SYDNEY WESTERN CITY PLANNING PANEL

COUNCIL ASSESSMENT REPORT

Panel Reference	2017SSW053
DA Number	DA-771/2017
Local Government Area	Liverpool City Council
Proposed Development	<p>The application proposes the construction of 2 x four-storey residential flat buildings containing a total of 64 units, including the demolition of existing buildings and lot consolidation.</p> <p>The application is lodged pursuant to the State Environmental Planning Policy (Affordable Rental Housing) 2009.</p>
Street Address	12-22 Willan Drive, Cartwright (Lots 344-349 in DP 227167)
Applicant	GAT and Associates
Owner	St George Community Housing Provider
Date of DA Lodgement	26 September 2017
Number of Submissions	One
Regional Development Criteria (Schedule 4A of the Act)	The development contains affordable housing with a capital investment value of \$20,260,605.
List of All Relevant 4.15(1)(a) Matters	<ul style="list-style-type: none"> • <i>List all of the relevant environmental planning instruments: Section 4.15(1)(a)(i)</i> <ul style="list-style-type: none"> • State Environmental Planning Policy (Affordable Rental Housing) 2009. • State Environmental Planning Policy No.65 – Design Quality of Residenti

Figure 4: Concept Building Envelope Plan for 24 Willan Drive.

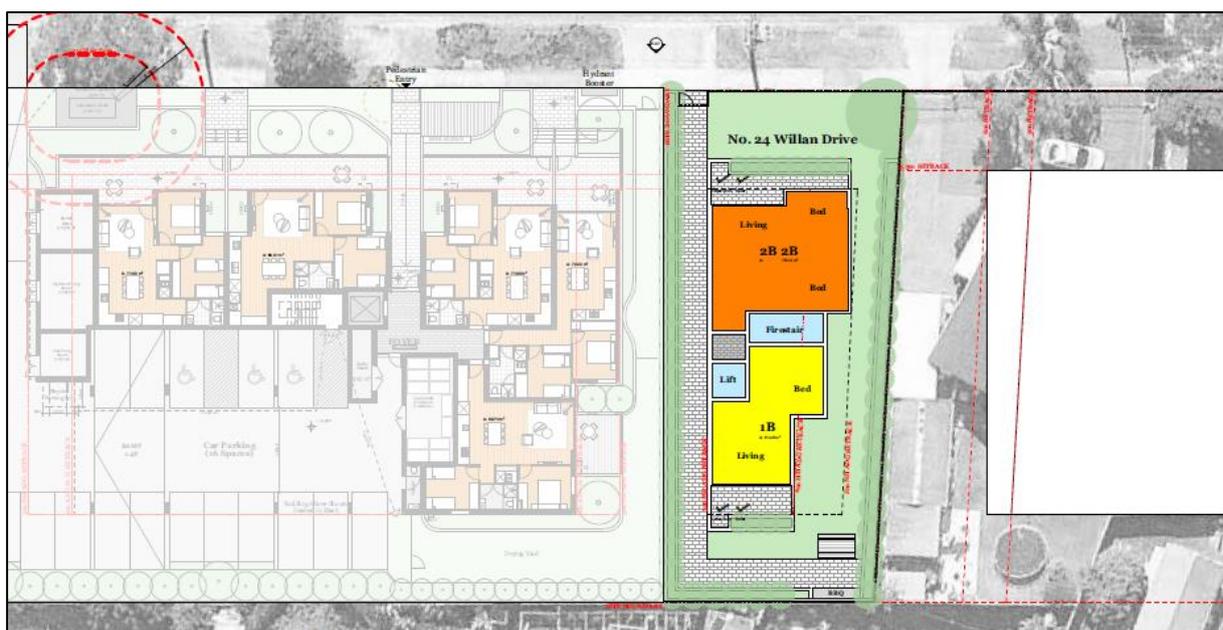
Consideration has been given to the second question in the *Cornerstone Planning Principle* should 24 Willan Drive not be amalgamated. The applicant has provided a building envelope plan (refer to the figure below) demonstrating the possible redevelopment of 24 Willan Drive.

The concept plan indicates that 24 Willan Drive can be redeveloped in an orderly and economic manner if isolated. Under the LLEP 2008, the site is zoned R4 High Density Residential, has a maximum building height of 15 metres and a maximum floor space ratio of 1:1.

The concept plan takes the minimum setback of 5.5m to the front as in accordance with the LDCP 2008 and side and the minimum rear setbacks of 3m and 6m, respectively as per Objective 3F-1 the ADG. The above controls determine the potential building envelope of this site.

Figure 7: Southern Elevation

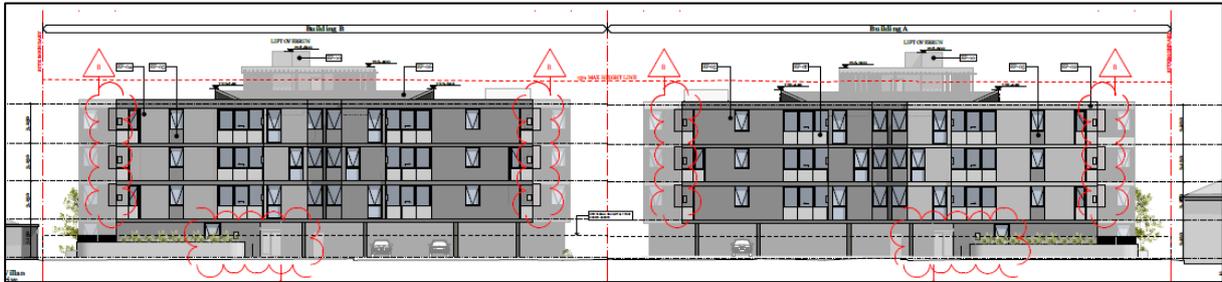
Comment: Development to the rear of the boundary currently comprises of single storey detached dwellings. However as shown in Figure 1, Council is currently assessing two development applications which adjoin the rear boundary of the proposed development. This includes a proposal for a child care centre at 203-205 Hoxton Park Road, and a 5-storey residential flat building at 207-211 Hoxton Park Road.

The proposed development provides an appropriate interface to the rear boundary, given that compliance is achieved in regards to the building separation distances as stipulated within ADG. An extract of the southern elevation is provided below.
